Re: East Montpelier Access Permit #17-025

ACCESS (CURB CUT) APPLICATION

**Haynes -- Upper North Street
East Montpelier**

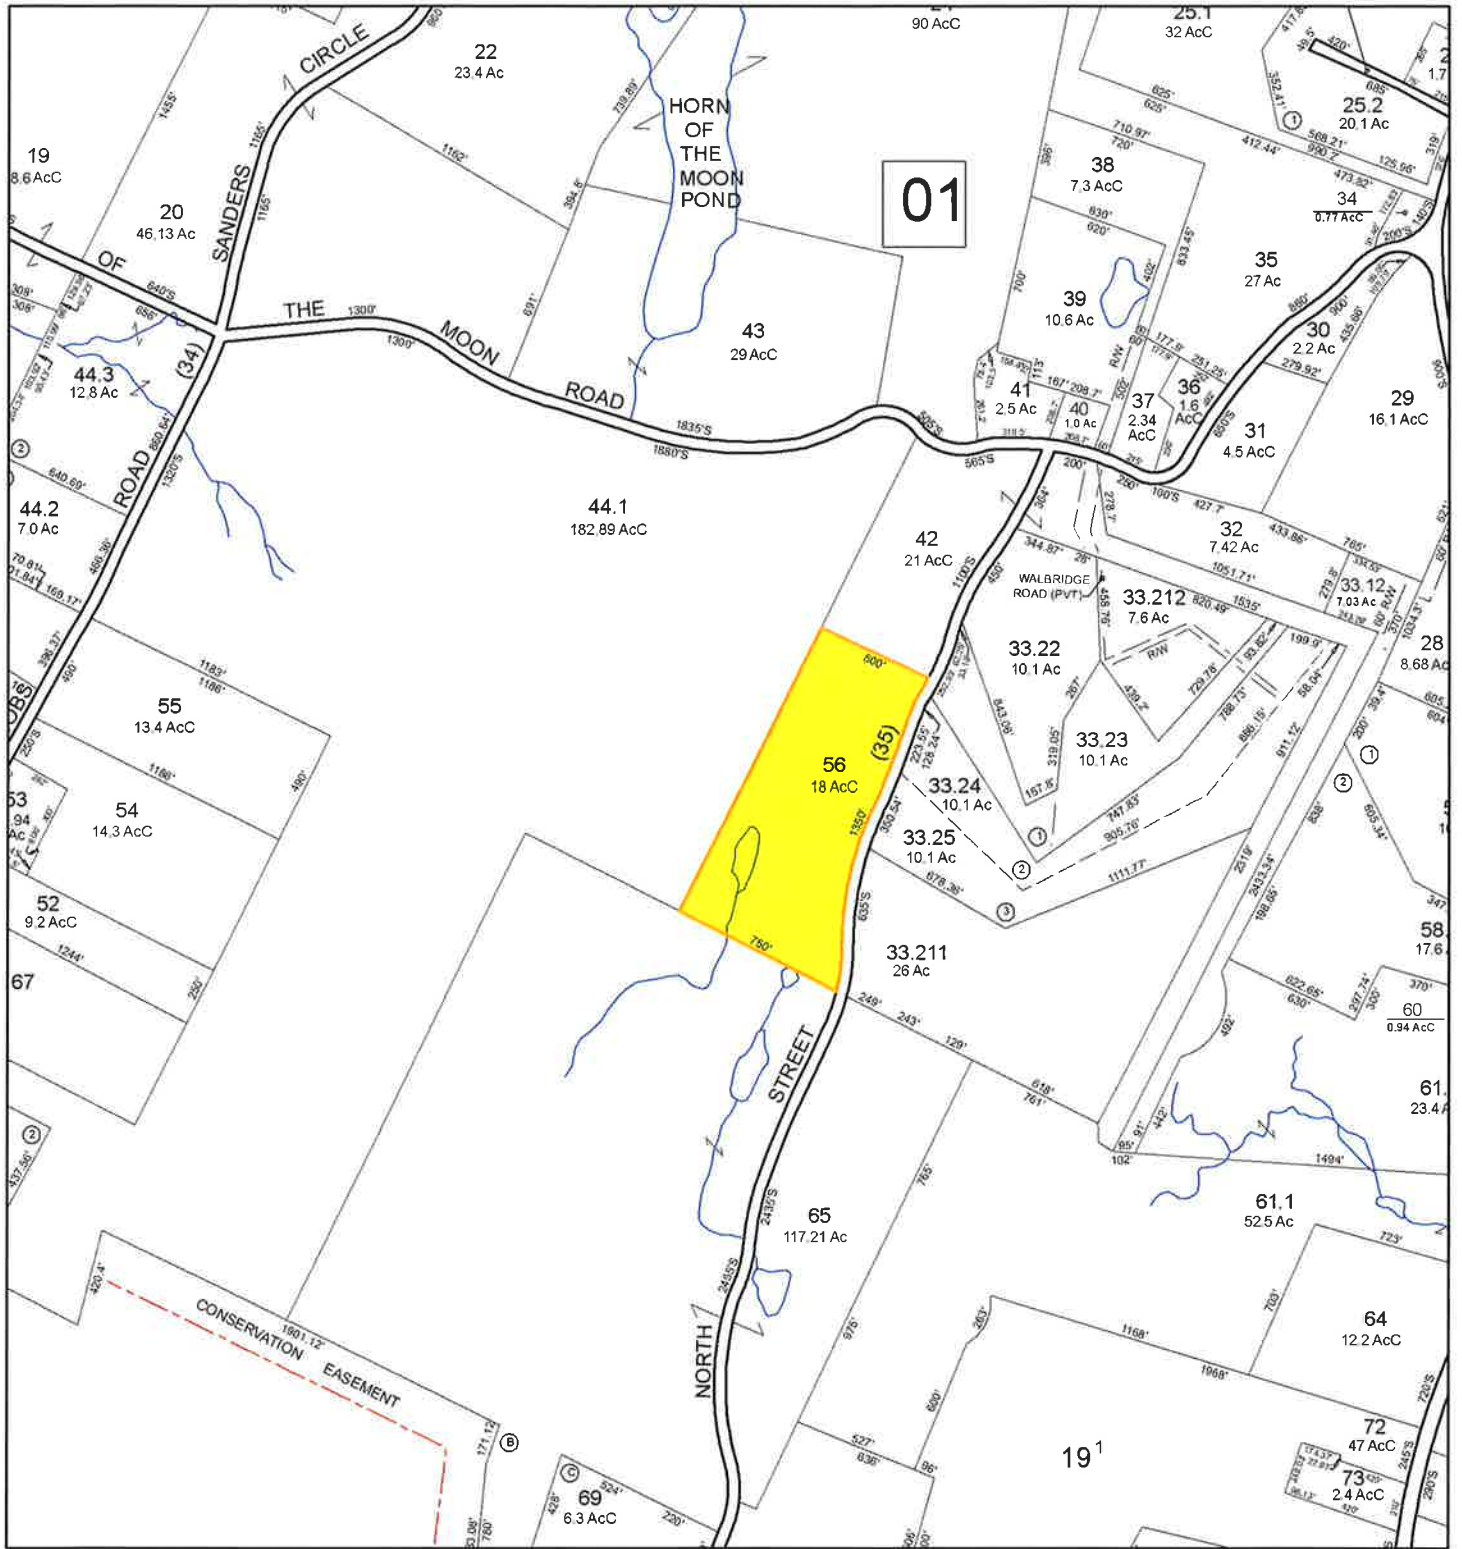
Proposed access meets applicable sight distance standards. Comments: Existing culvert needs to be replaced. Good sight dista
330' work

Existing culvert in poor condition needs to be replaced with a 15" x 40" Gray plastic culvert inlet and outlet headwalls. all excavated material needs to be seeded and mulch
